Jersey Jack Pinball

Service Bulletin
P-2

GAME: Pirates of the Caribbean Pinball

SUBJECT: Extended Tortuga VUK snubber bracket.

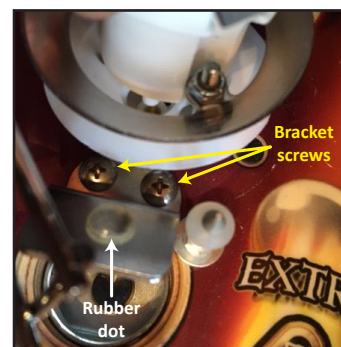
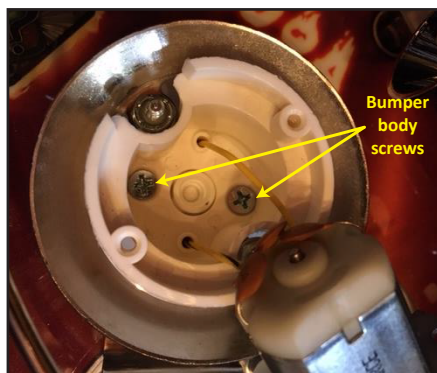
1a) **LE/CE:** Using a 5/64" Allen wrench, loosen (do NOT remove) set screw holding pirate and barrel sculpture to spinning pop bumper motor shaft (see picture below, left). Carefully slide sculpture straight up and off of shaft. Using a #1 Phillips screwdriver, remove two screws AND nylon spacers holding spinning motor mount to pop bumper body (see picture below, left center). Leave motor loose inside pop bumper body.

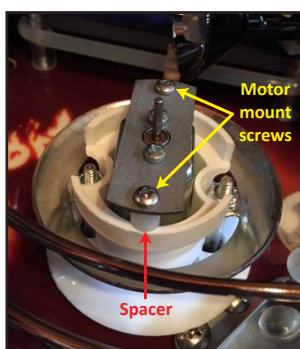
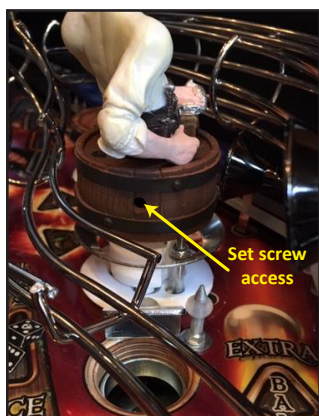
2) Using a #2 Phillips screwdriver, remove two flathead screws holding pop bumper body to PF surface (see picture below, right center). Use same screwdriver to remove two screws holding existing snubber bracket to PF surface (see picture below, right).

3) Add a small amount of BLUE Loctite thread locker to ends of snubber bracket screws. Install new, extended snubber bracket, using these screws; tighten **FIRMLY**. Peel clear rubber dot (for ball trap prevention) off of old snubber bracket and attach it to top of new, extended bracket.
